DESIGN AND CONSTRUCTION MANUAL DESIGN MODIFICATION REQUEST

PROJECT NAME: Longview Mansion – Parking Lot Addition

RE: PL2023291 – Longview Mansion – Parking Lot Addition

NLV MANSION PARKING LOT
PROPOSED CONDITIONS DRAINAGE MAP

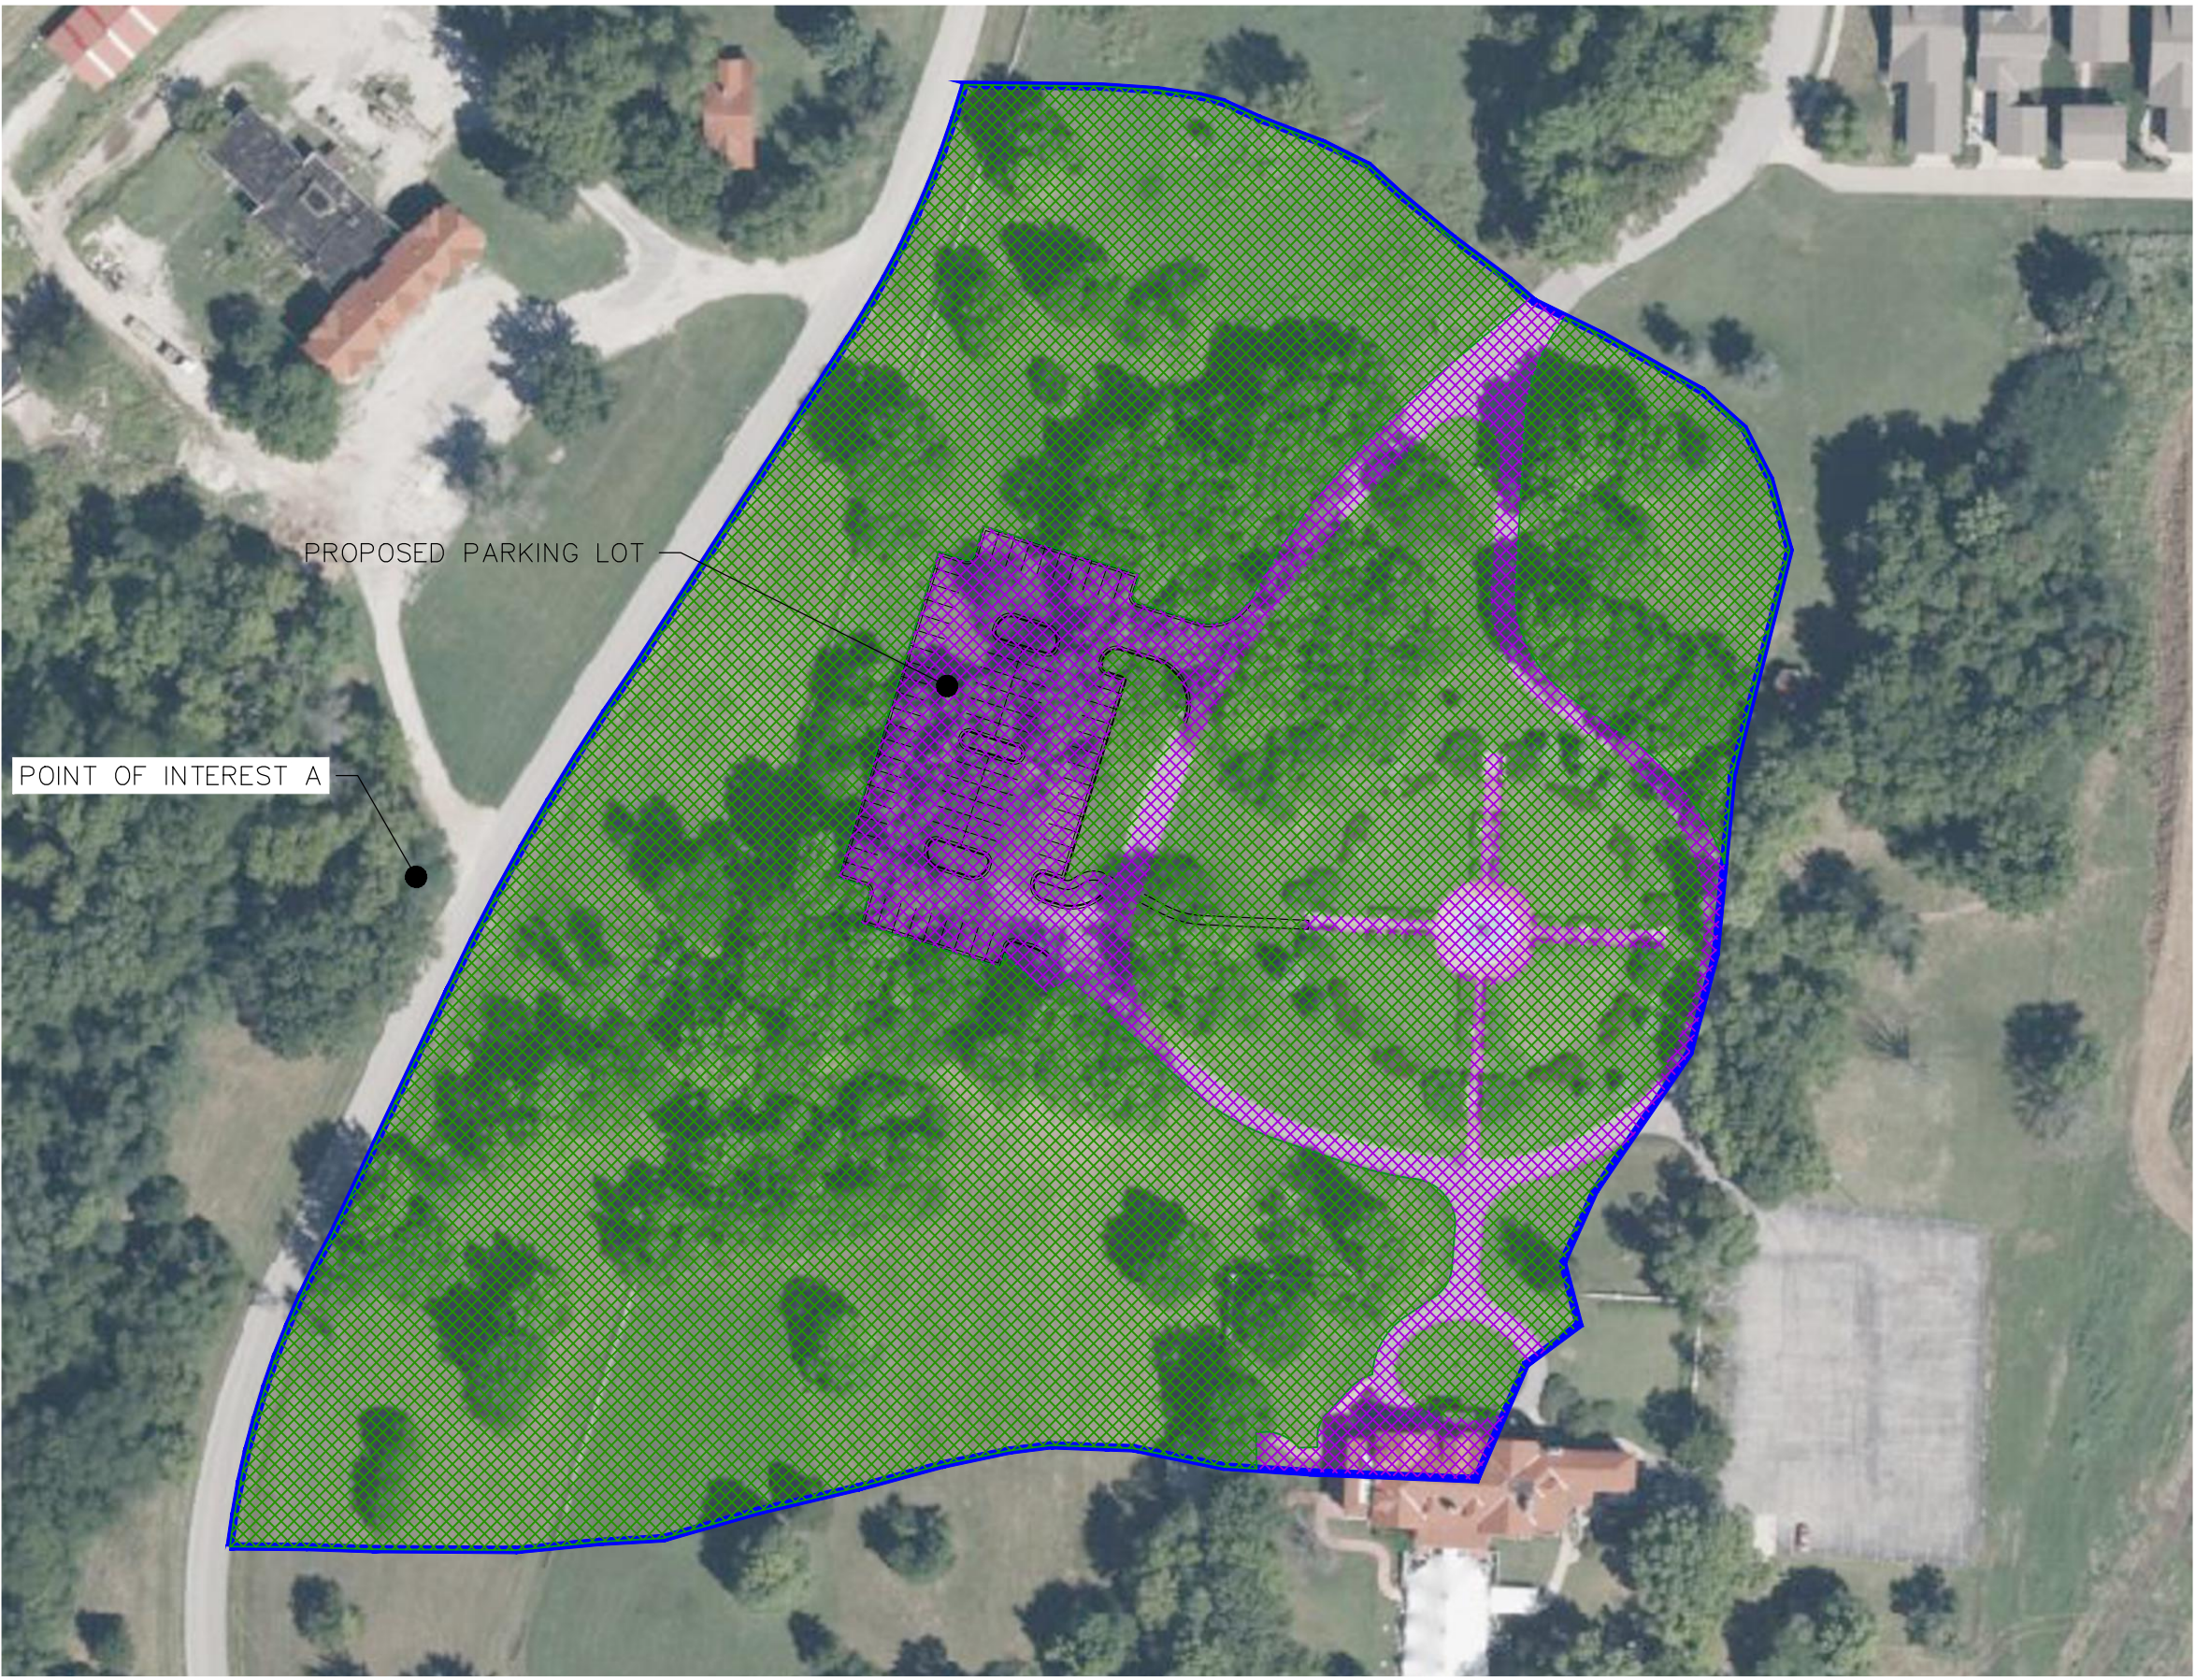
To meet or reduce the increase of stormwater overtopping SW County Park Road compared to existing conditions, a 15" HDPE pipe is proposed to run parallel to the existing 24" CMP with the same invert elevations.

Tables 11, 12, and 13 show increases of flow from the proposed condition compared to the allowable release rates and existing conditions at the Point of Interest, except for the 10-year flow due to the proposed 15" pipe. The 15" pipe removes the overtopping of stormwater of the road in the 10-year proposed condition and reduces the amount of stormwater overtopping the road in the 100-year proposed condition.

With the reduction in stormwater overtopping SW County Park Road and the increase of stormwater being directed under the road towards Longview Lake, a waiver is requested that the proposed conditions be accepted as is, with the increase of these flows. It should be noted that the increase of the flow to existing conditions is not more than 5% for all storm events.

NLV MANSION PARKING LOT
BMP MAP

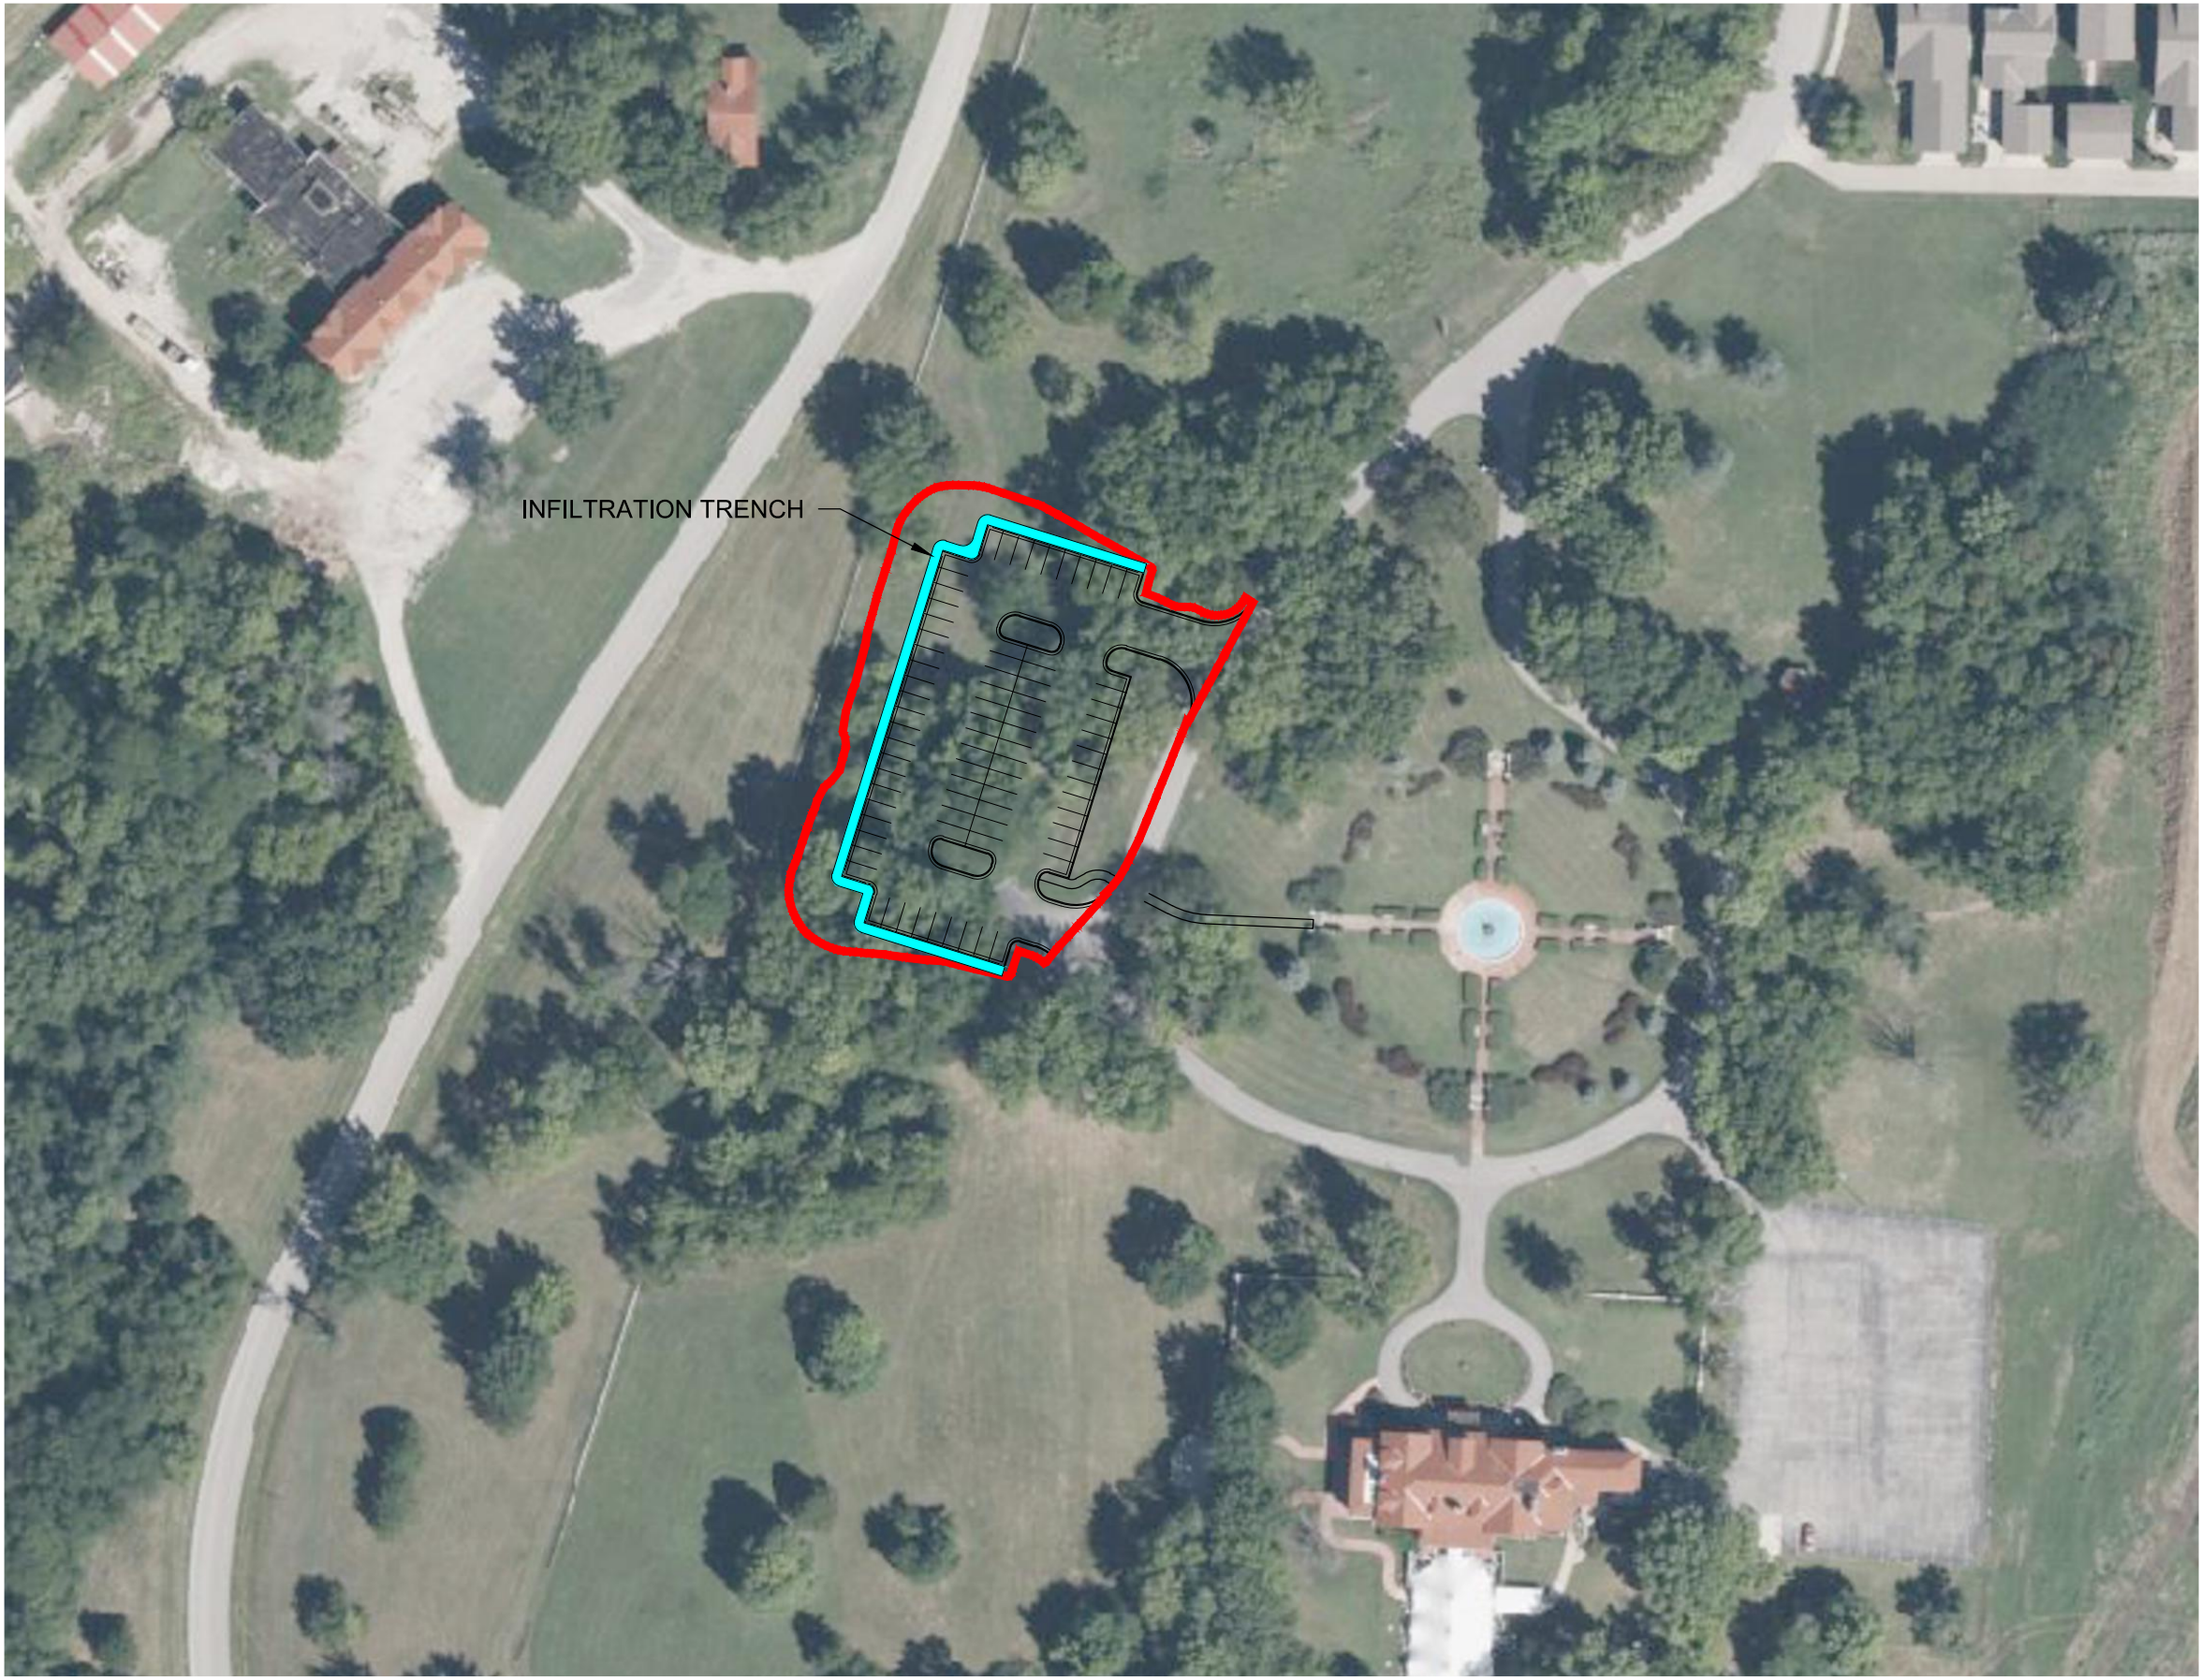
To protect the water quality of stormwater runoff from the proposed improvements, an infiltration trench will be constructed around the north, west, and south sides of the parking lot. The infiltration trench will capture and treat the entire parking lot to a Level of Service rating of 9.00. Stormwater flowing to the 24" CMP and 15" pipe will be reduced by the trench for the water quality storm event.

Peak runoff rate results shown above do not include analysis of the effects of the water quality infiltration trench. Although not modeled, the infiltration trench will provide a storage volume of 0.09 acre-feet, which exceeds the increase in volume runoff produced by the parking lot improvements in the 2-yr and 10-yr storm events, and the majority of the increase in volume produced by the 100-yr storm event. Existing and proposed volumes are summarized below:

Although detention for the proposed parking lot is requested to be waived, water quality volume requirements must be met through BMPs. The treatment area for the BMPs will only include areas of disturbance, and not the entire drainage area. BMP Worksheet 1 in Appendix C shows that the level of service required for the parking lot is a 7, with most of the disturbed area being impervious.

With the requirement of a level of service 7, an infiltration trench will be used with the high value rating and versatile footprint required to meet the level of service. The soil type, Greenton silty clay loam, that covers the entire disturbed area for the parking lot, has a low hydraulic conductivity and would not naturally be able to drain the treatment area under 72 hours, a requirement per the MARC Manual. Soil with a hydraulic conductivity rate of 2 micrometers/second or higher must be placed at a depth of 2' minimum below the infiltration trench to obtain proper hydraulic conductivity. A perforated pipe to drain heavy stormwater flows to the point of interest within the drainage area (see Exhibit-03 in Appendix A). A worksheet for calculations of the infiltration trench can be found in Appendix C that show meeting the design criteria for water quality volume.
